CMF SUBDIVISION

APPLICATION NUMBER 12 DATE September 1, 2011

REQUEST Subdivision

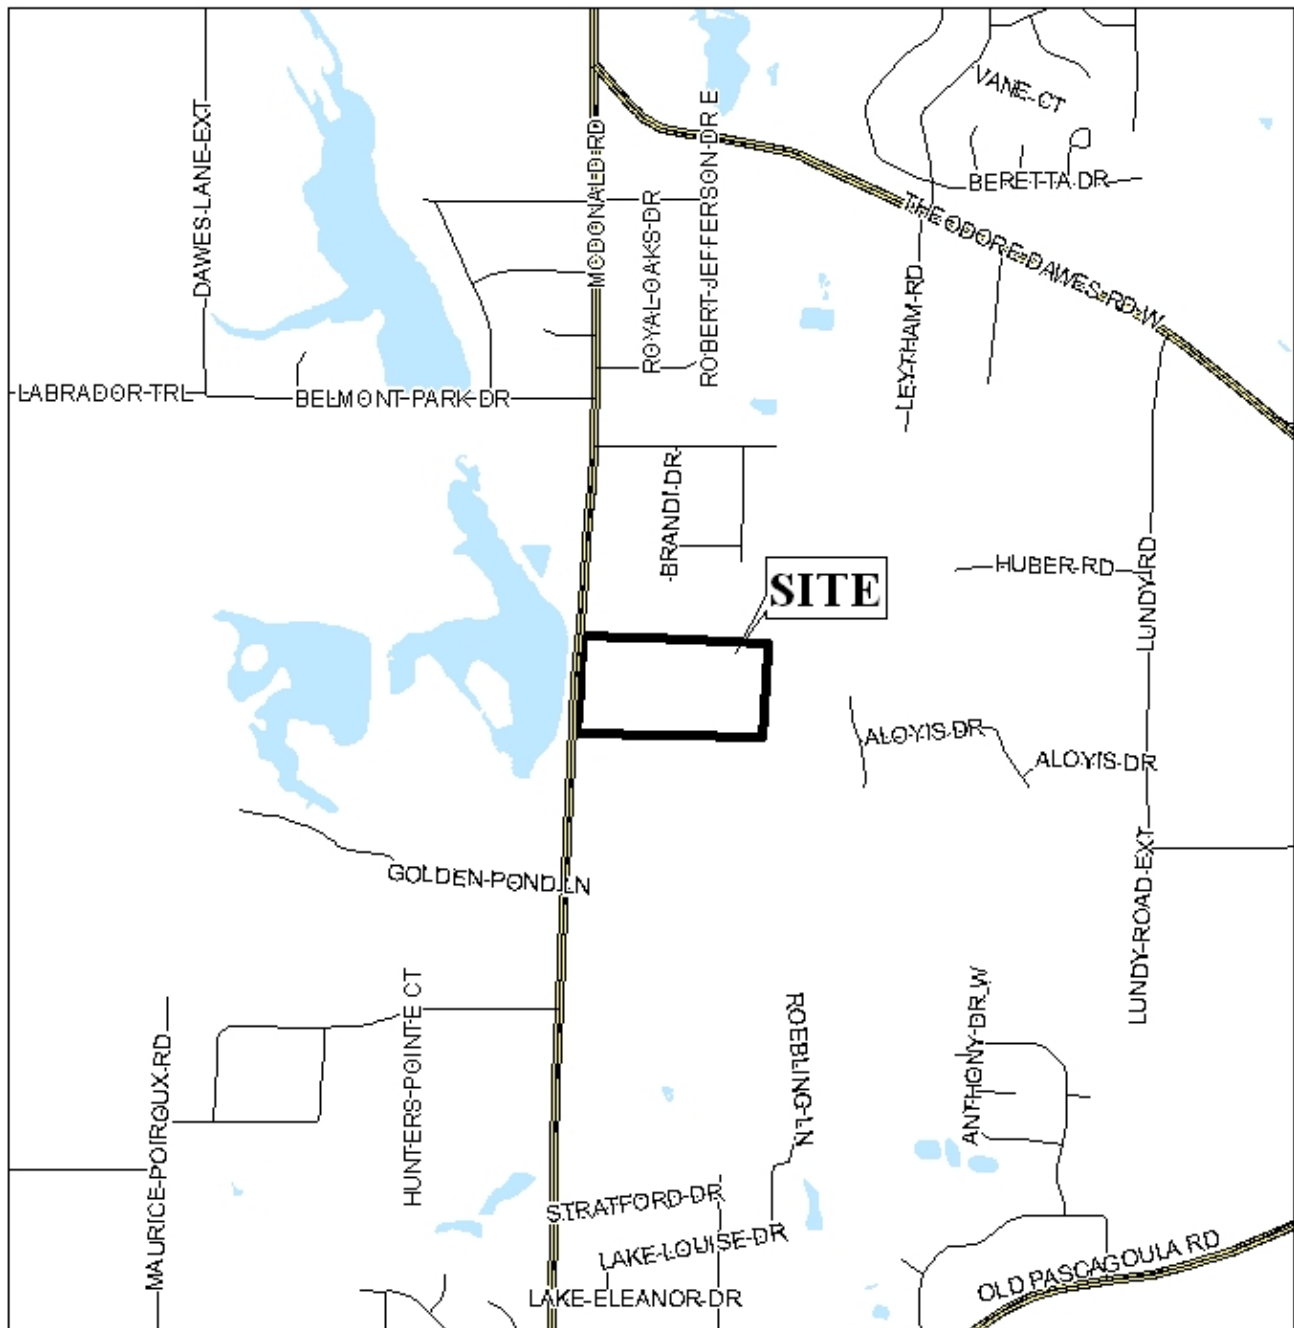
The plat illustrates the proposed 2-lot, 19.3 acre \pm subdivision which is located at 5851 & 5873 McDonald Road (East side of McDonald Road, 1,250' \pm South of Holloway Drive North). The applicant states that the subdivision is served by public water, well, and individual septic systems.

The purpose of this application is to modify an interior lot line between two metes and bounds parcels. The lot line is proposed to shift so that the shared driveway and curb cut is evenly split and to provide an equal land swap between the two proposed lots.

Both of the proposed lots meet the minimum size and frontage requirements as regulated by Section V.D.2. of the Subdivision Regulations. The proposed Lot 1 does not comply with Section V.D.3. of the Subdivision Regulations regarding the maximum width to depth ratio; however, given that the parcel is existing and that the non-conformity will only be marginally increased, and that there are several other lots in the immediate area which exceed the maximum width to depth ratio, a waiver of Section V.D.3. may be appropriate.

The 25-foot minimum building setback line is depicted on the preliminary plat, and this should be retained on the Final Plat, if approved. The lot area sizes are depicted in acres and square feet, and this should also be retained on the Final Plat, if approved.

The proposed lots front McDonald Road, a planned major street as shown on the Major Street Plan Component of the Comprehensive Plan. The Plan requires a 100-foot right-of-way for McDonald Road in this area. The plat depicts the existing right-of-way as 80 feet. As such, dedication sufficient to provide 50 feet from the centerline of McDonald Road should be required.

Because McDonald Road is a planned major street, access management is a concern. As stated previously, each lot will have one existing shared curb cut to McDonald Road, should this application be approved. As such, each lot should be limited to the shared existing curb cut, with the size, design, and location of all curb cuts to be approved by County Engineering and conform to AASHTO standards.

The site is in Mobile County, however, it will have to comply with the City of Mobile storm water and flood control ordinances. A note should be placed on the Final Plat, if approved, stating that the development will be designed to comply with the storm water detention and drainage facility requirements of the City of Mobile storm water and flood control ordinances, and requiring submission of certification from a licensed engineer certifying that the design complies with the storm water detention and drainage facility requirements of the City of Mobile storm water and flood control ordinances prior to the issuance of any permits. Certification is to be submitted to the Planning Section of Urban Development and County Engineering.

Based on the preceding, and with a waiver of Section V.D.3. of the Subdivision Regulations regarding maximum width to depth ratio, this application is recommended for tentative approval subject to the following conditions:

- 1) dedication sufficient to provide 50 feet from the centerline of McDonald Road;
- 2) placement of a note on the Final Plat stating that each lot is limited to the existing shared curb-cut each to McDonald Road with the size, design and location to be approved by Mobile County Engineering and conform to AASHTO standards;

- 3) retention of the 25-foot minimum building setback line and lot area sizes, in square feet, as shown on the preliminary plat;
- 4) placement of a note on the Final Plat stating that: *“Development must comply with the Mobile County Flood Damage Prevention Ordinance. Development shall be designed to comply with the storm water detention and drainage facility requirements of the City of Mobile storm water and flood control ordinances, and requiring submission of certification from a licensed engineer certifying that the design complies with the storm water detention and drainage facility requirements of the City of Mobile storm water and flood control ordinances prior to the issuance of any permits.”*
